## **BOARD ACTION REPORT – APPEALABLE ITEM**

Ligotti Medical Center

Architectural elevation changes associated with a Class I site

## SITE PLAN REVIEW AND APPEARANCE BOARD MEMORANDUM STAFF REPORT

Architectural Elevations

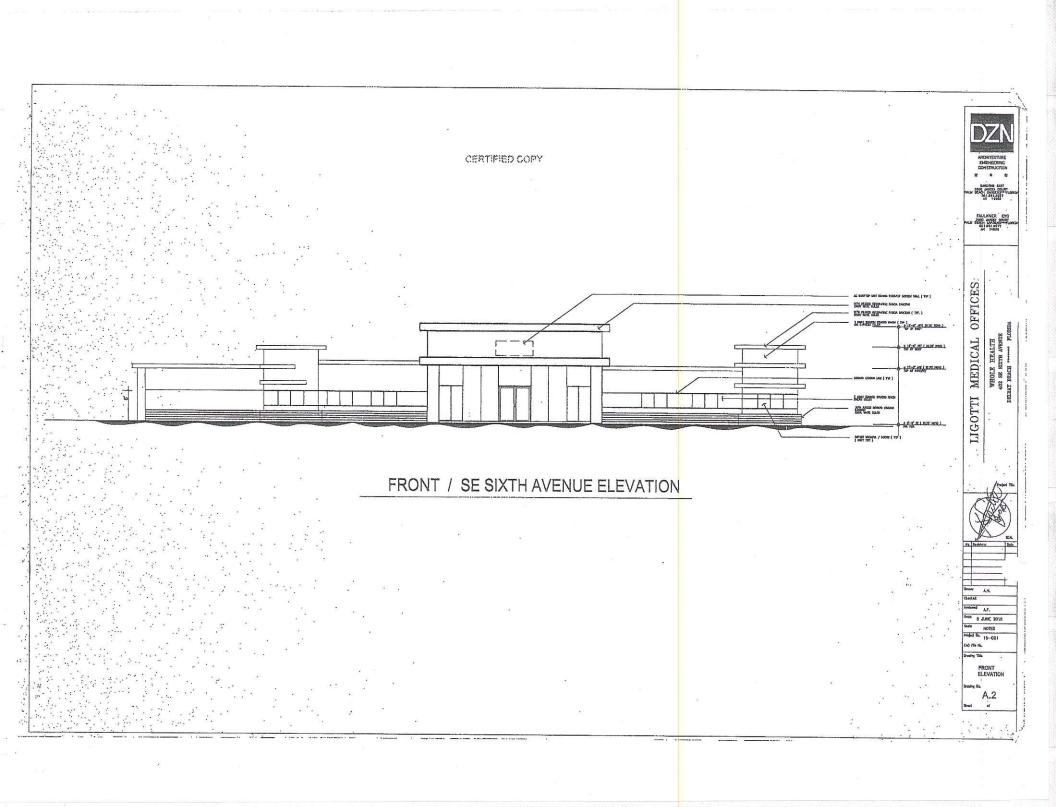
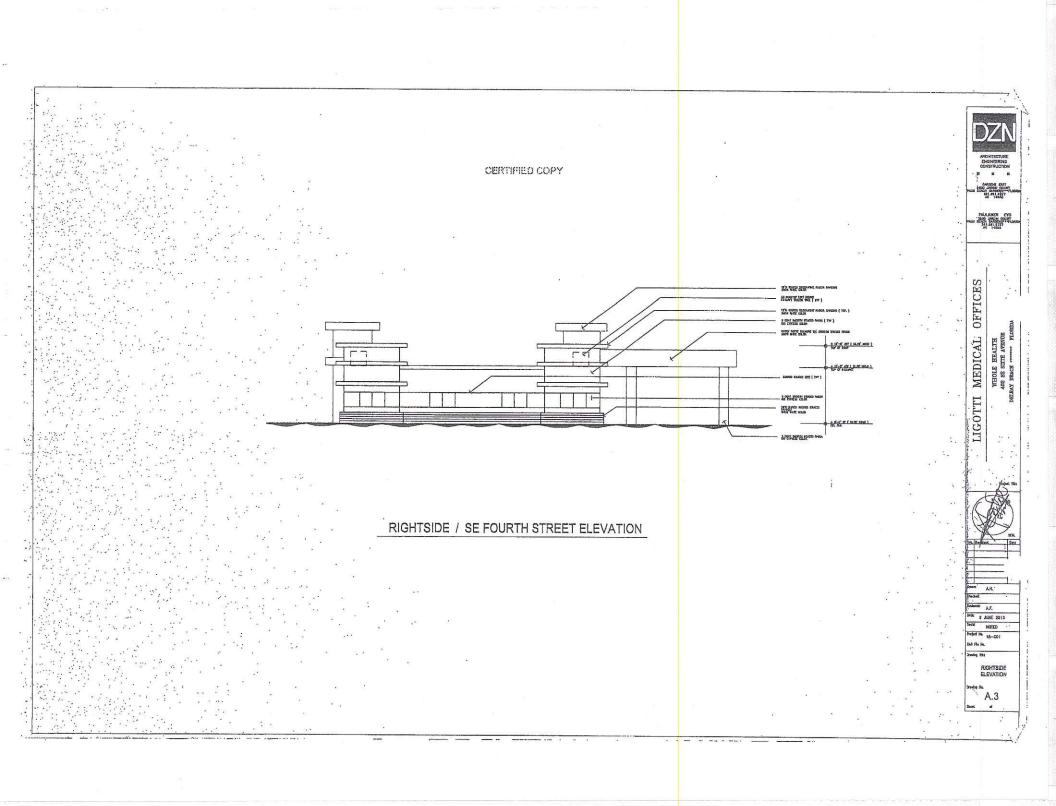
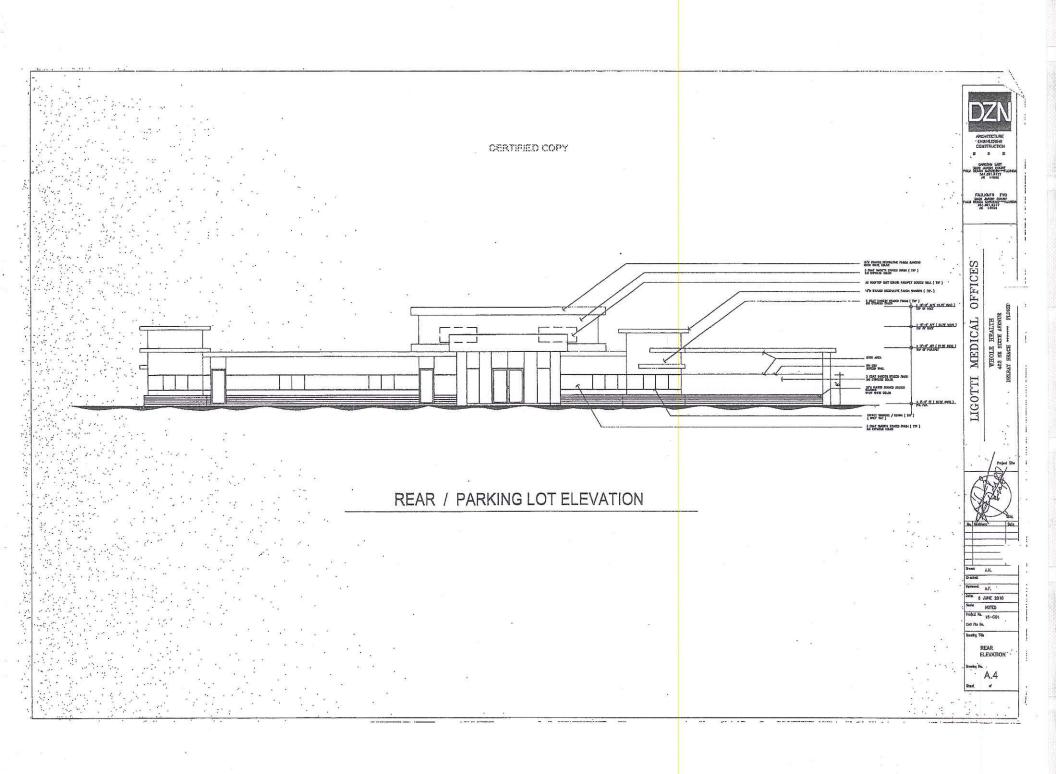
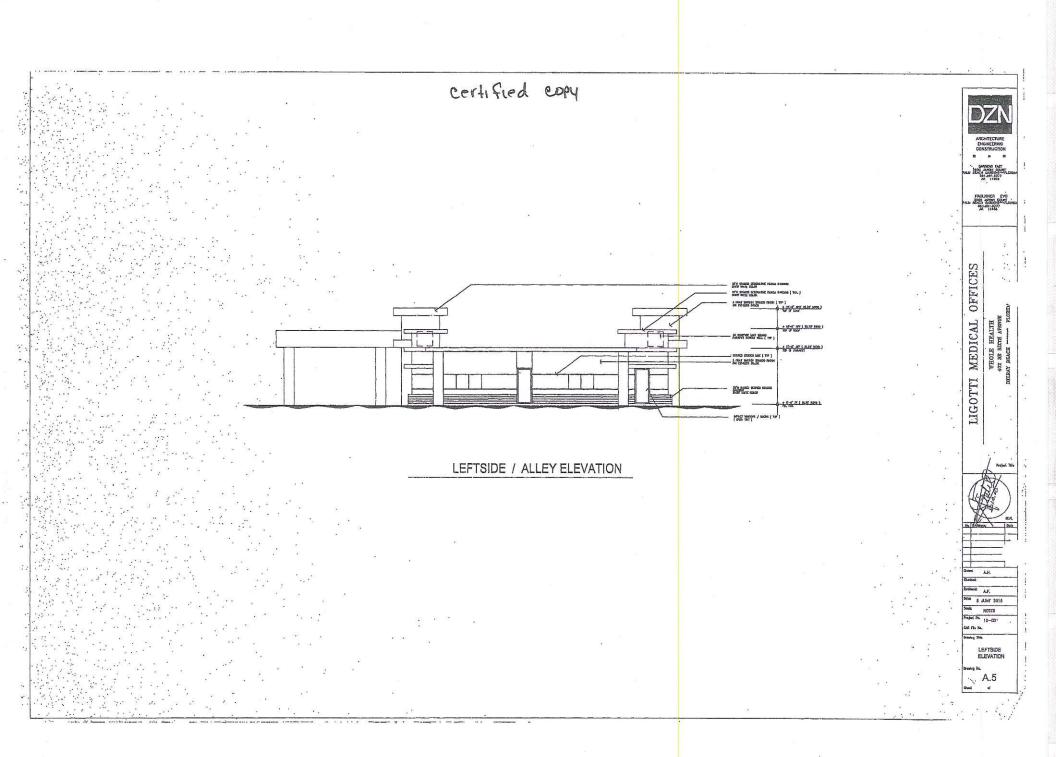
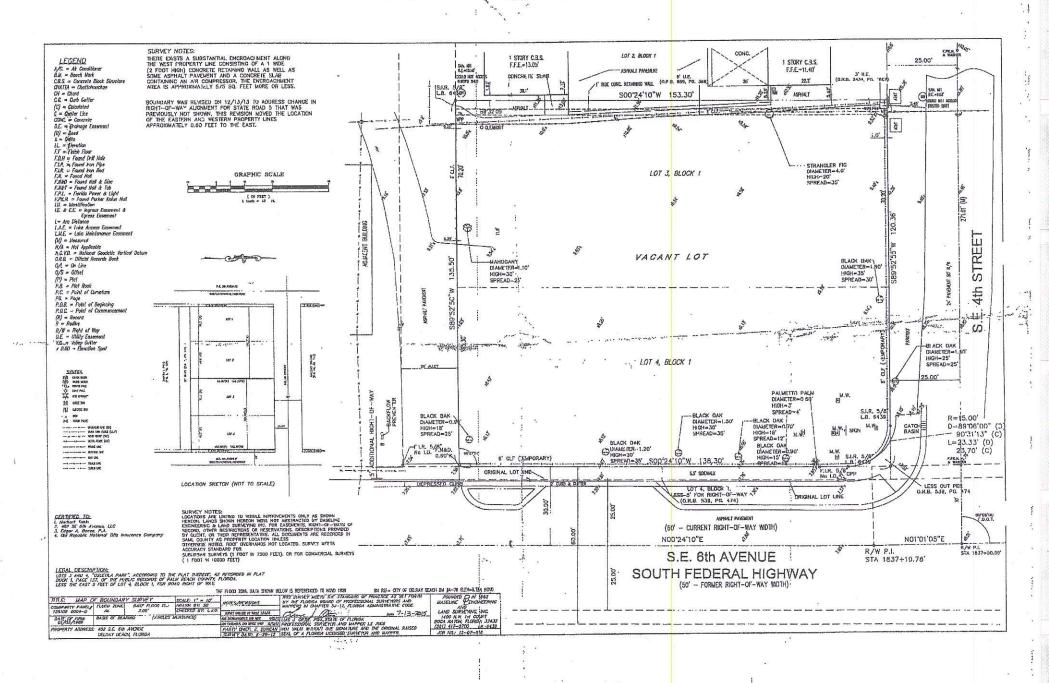
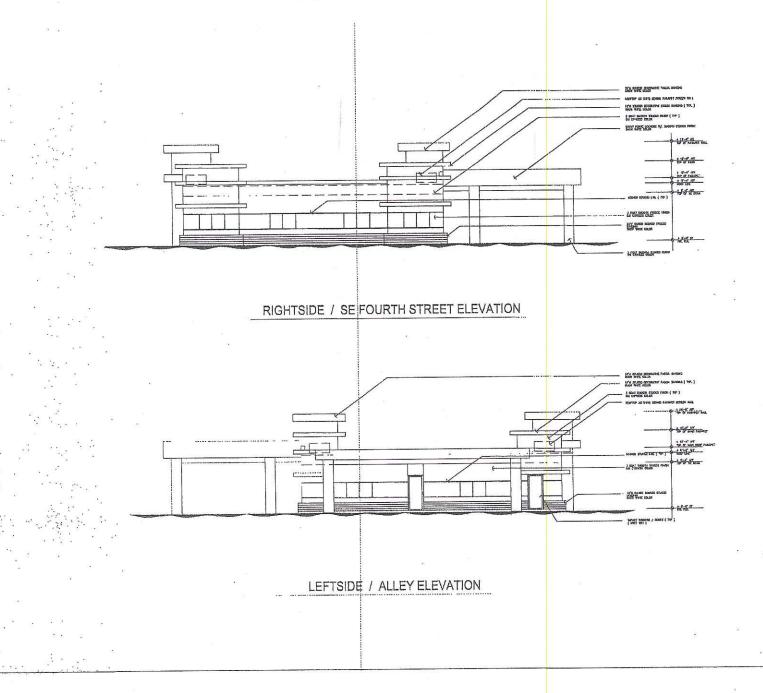
The proposal before the board was to reconcile inconsistencies in the "as built" elevations as compared to the certified plans with respect to building height.

The building still complies with the maximum building height per LDR Section 4.3.4(K) as it pertains to the GC (General Commercial) zone district which is 48'. Per the table that is provided below, the "as built" was approximately 1.6 feet higher than approved by the board on May 27, 2015 and the certified plans on August 26, 2015.

The building still complies with the maximum building height per LDR Section 4.3.4(K) as it pertains to the GC (General Commercial) zone district which is 48'. The applicant has provided the parapet height on the "as built" of 11'4" and a maximum of 19'8" to the top of the parapet.

While the proposed building complies with the height requirement, LDR section **4.3.4(j)(3)(c)**, Parapets, states that the maximum height of the parapet wall shall be 6', or sufficient height to screen all roof mounted equipment whichever is greater. The parapets on the certified and on the "as built" plans measure 8' in height from the flat roof to the top of the parapet. This was listed as a condition of approval in the certified plans to screen the AC units properly.

The applicant has complied with all other conditions that were set forth during certification and the building process. The architectural elevations and building height meet LDR requirements and are compatible and harmonious with the surrounding areas and are an enhancement to the neighborhood. Based upon the above, positive findings can be made with regard to the criteria listed in LDR Section 4.6.18(E).
